Technical Note TN-922-SR

Tait Orca 5010, 5015, 5020 Firmware Upgrade to 2.14 & TOP-CPA Upgrade to 4.0.1

15 October 2004

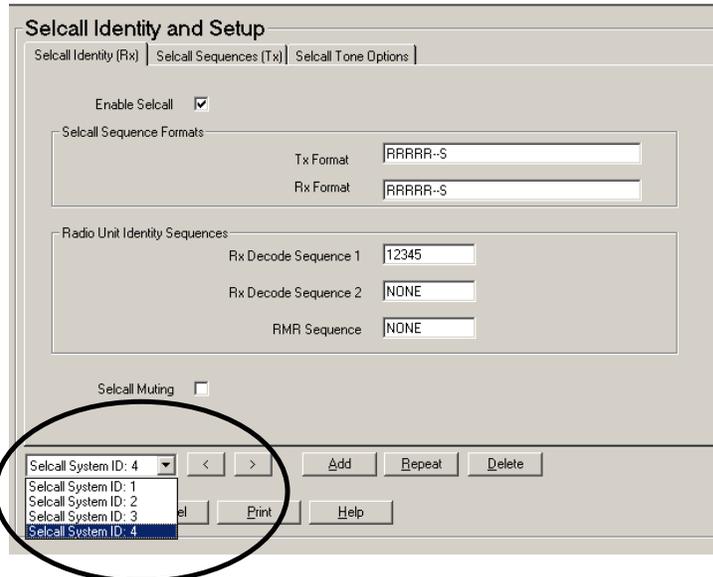
- FOCUS 16698: Under some specific scanning conditions it was occasionally possible for the CTCSS sub-audible decoder to open the radio mute upon receipt of an incorrect CTCSS sub-audible frequency. Therefore a new option has been added to the 'Scan Group' page called 'Fast CTCSS Decode Override', this is pictured below. This disables the "fast" CTCSS sub-audible decoding that is performed when the radio is in a scan group. (Raised as TIMS 30050).
